ADDENDUM 1 – JOB 23

TO: All prospective bidders on Projects NHU-1-806(052)071 and IM-1-094(200)153, Job No. 23 scheduled for the November 13, 2020 bid opening.

PLAN ADDENDUM SUMMARY AND APPROVAL

Project Information							
Project: NHU-1-806(052)071 & IM-1-094(200)153					PCN: 22181 & 22182		
Location: Interstate 94 (Mandan Ave Interchange); ND 1806 (Interstate 94 to 27 th Street)							
Date: November 4, 2020			Project Manager: Troy Ripplinger (KLJ)				
Bid Opening Date: November 13, 2020			JOB#: 23		Addendum#: 1		
Section	Sheet	Description of Change					
2	2	Added Standard Drawing D-752-2 Chain Link Fence					
6	5	Revised note 724-P04 to include circular deflection and leakage testing and retesting					
6	6	Note 724-P10 moved from sheet 5 to sheet 6.					
6	8	Revised wording in note 770-P02.					
8	1	Text shifted due to bid item added on Section 8 Sheet 1.					
		Removed Bid Items:					
		Spec	Code	Description	Unit	Previous Quantity	Addendum 1 Quantity
		411	0100	MILLING PAVEMENT SURFACE	TON	13340	0
		Added Bid Items:					
		Spec	Code	Description	Unit	Previous Quantity	Addendum 1 Quantity
		411	0105	MILLING PAVEMENT SURFACE	SY	0	13340

ND 1806
Allowable Pipe List
Approach Culverts

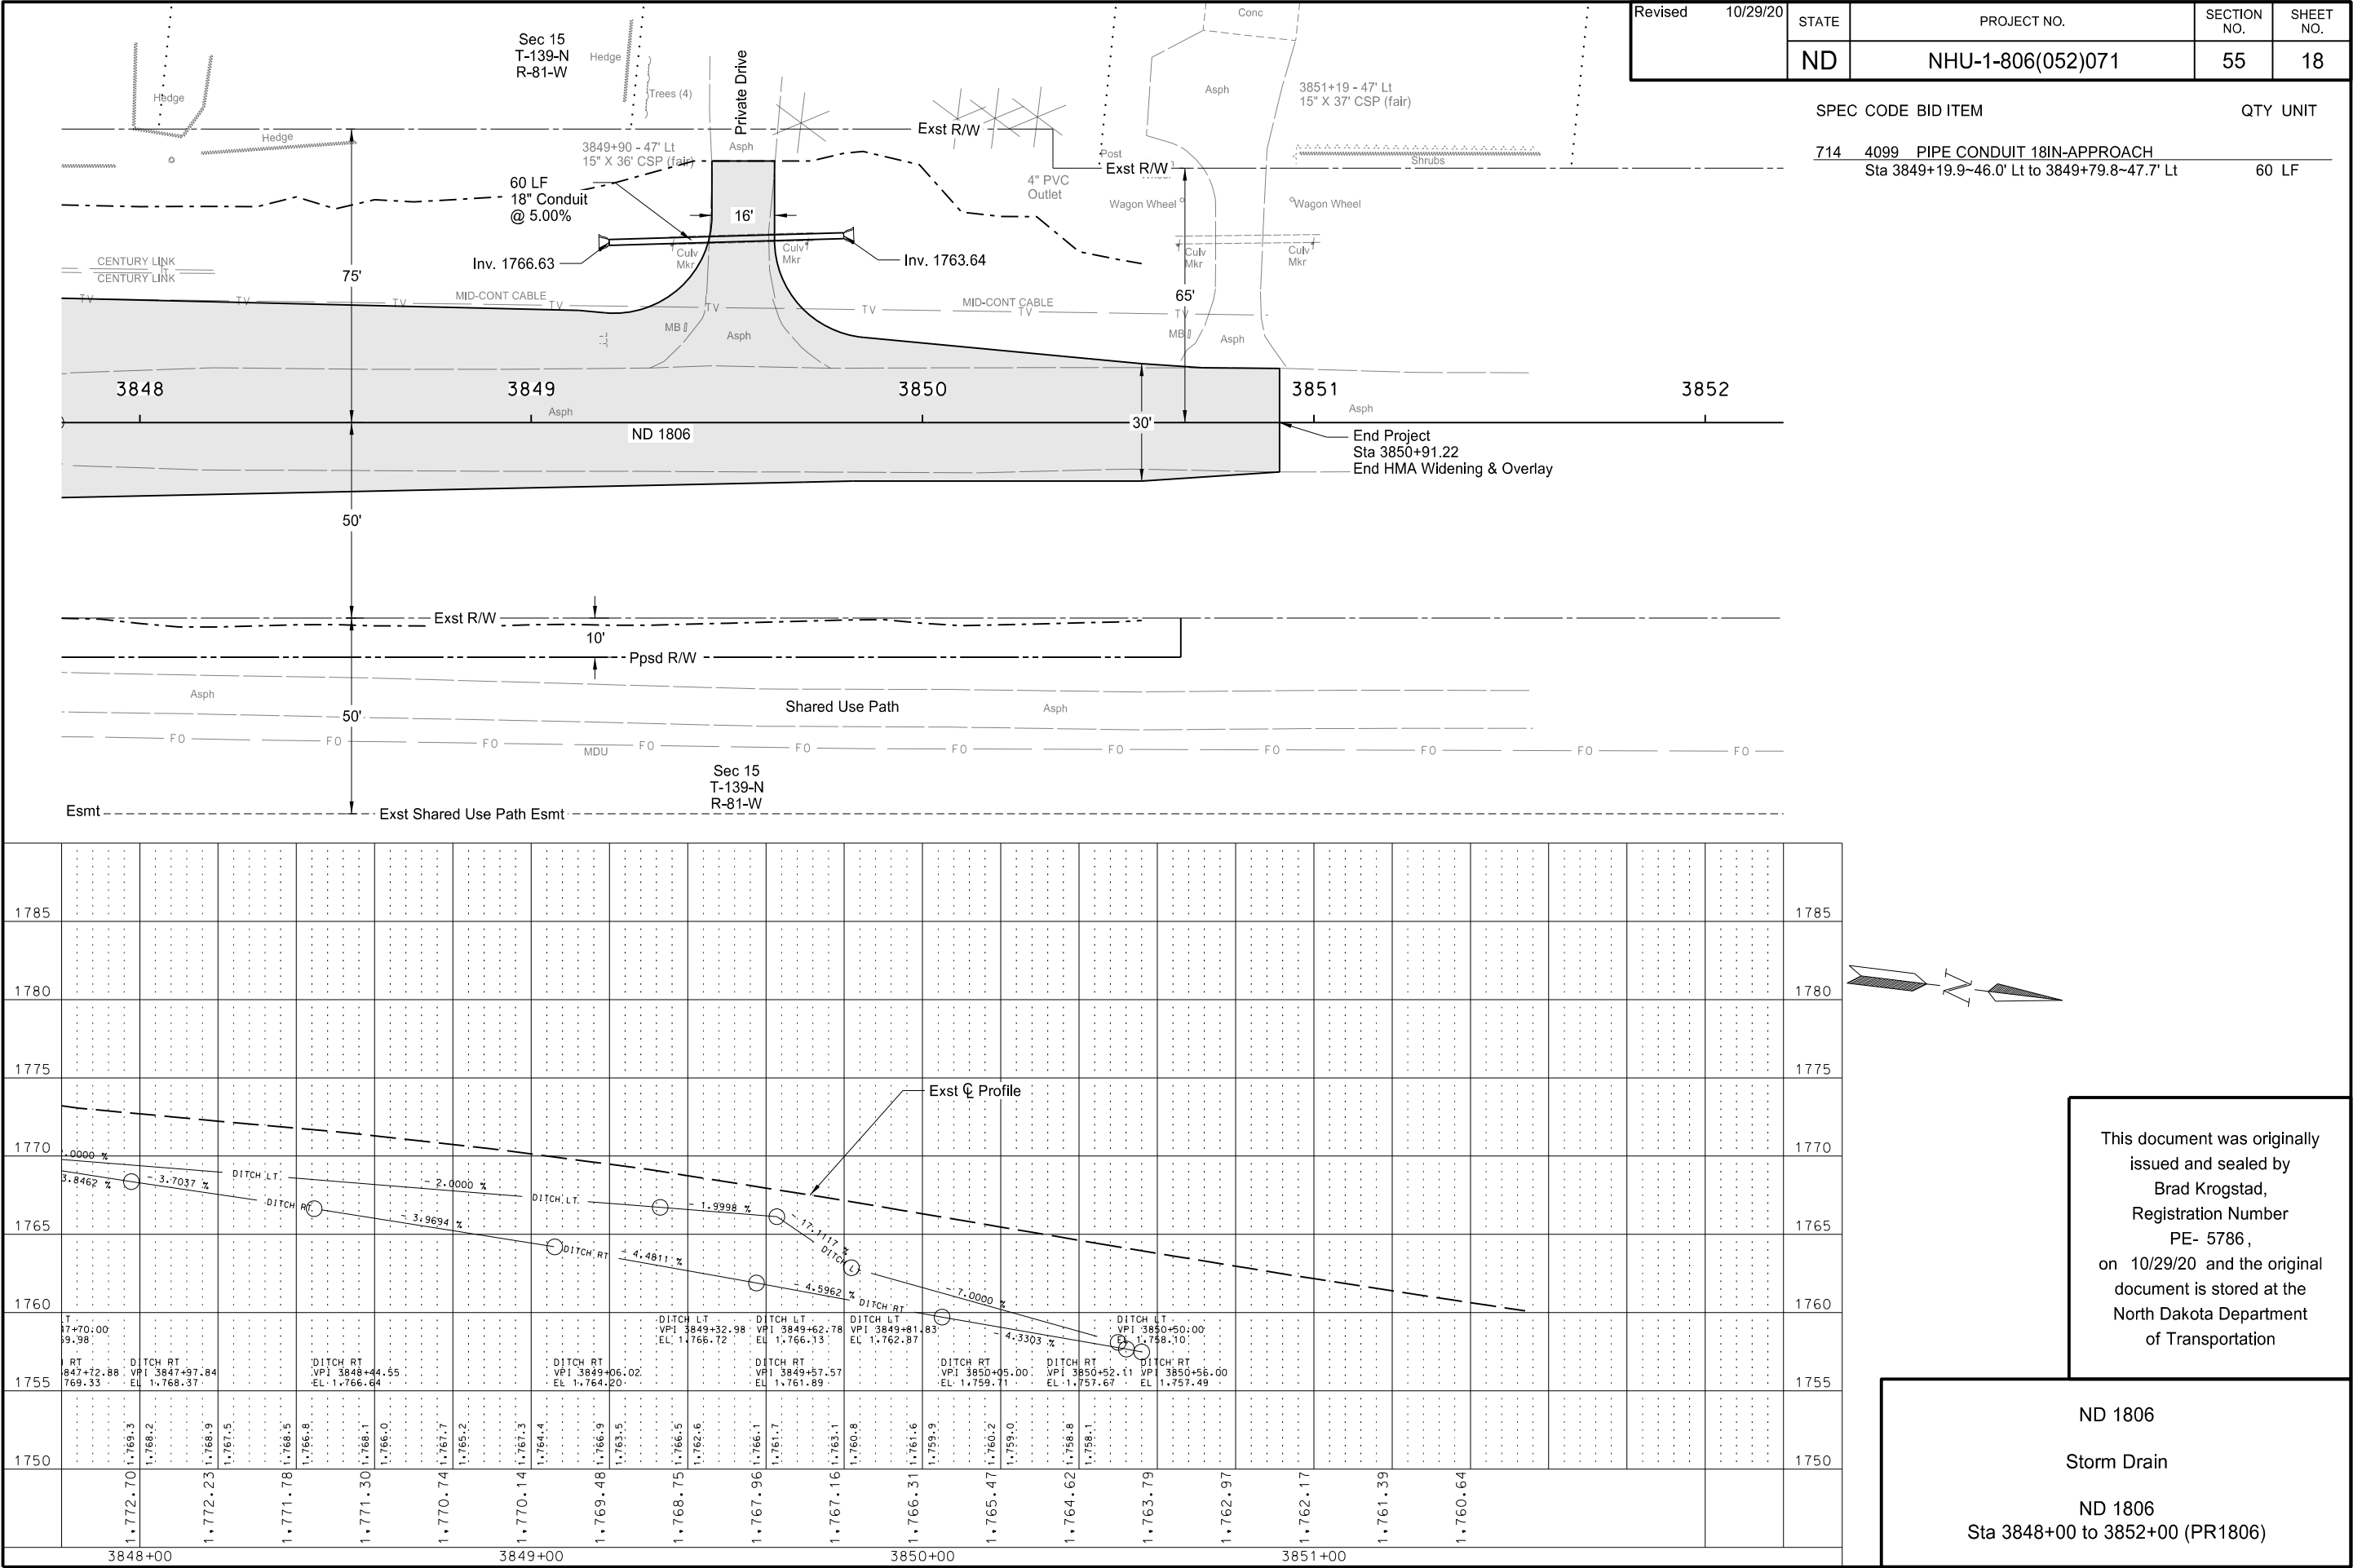
Culvert at Sta 3800+95.0~38.6' Rt to 3801+55.0~38.6' Rt invert elevations updated from 1742.27 & 1742.57 to 1742.02 & 1742.32.					
		Revised Quantities:					
		Spec	Code	Description	Unit	Previous	Addendum 1

Quantity	Quantity	
		714	4096	PIPE CONDUIT 15IN-APPROACH	LF	60	0
		714	4099	PIPE CONDUIT 18IN-APPROACH	LF	0	60
55	18	Culvert at Sta 3849+19.9~46.0' Lt to 3849+79.8~47.7' Lt updated from 15IN to 18IN. Revised Quantities:					
		Spec	Code	Description	Unit	Previous Quantity	Addendum 1 Quantity
		714	4096	PIPE CONDUIT 15IN-APPROACH	LF	60	0
		714	4099	PIPE CONDUIT 18IN-APPROACH	LF	0	60
200	36-39	Culvert at Sta 3800+95.0~38.6' Rt to 3801+55.0~38.6' Rt updated from 15IN to 18IN. Culvert at Sta 3800+95.0~38.6' Rt to 3801+55.0~38.6' Rt invert elevations updated from 1742.27 & 1742.57 to 1742.02 & 1742.32.					
200	107-108	Culvert at Sta 3849+19.9~46.0' Lt to 3849+79.8~47.7' Lt updated from 15IN to 18IN.

3849+19.9	46.0' Lt	3849+79.8	47.7' Lt	18	Pipe Conduit - Approach	60	Reinforced Concrete Pipe - Class III (Barrel Length = 54 LF)	18				FES	FES	Specification 714.04 A
							Corrugated Steel Pipe	18	Z, A, P	2	0.064			
							Spiral Rib Steel Pipe	18	Z, A, P	3/4, 1	0.064			
							High-Density Polyethylene	18						
							Polypropylene Pipe (AASHTO M330, Type S)	18
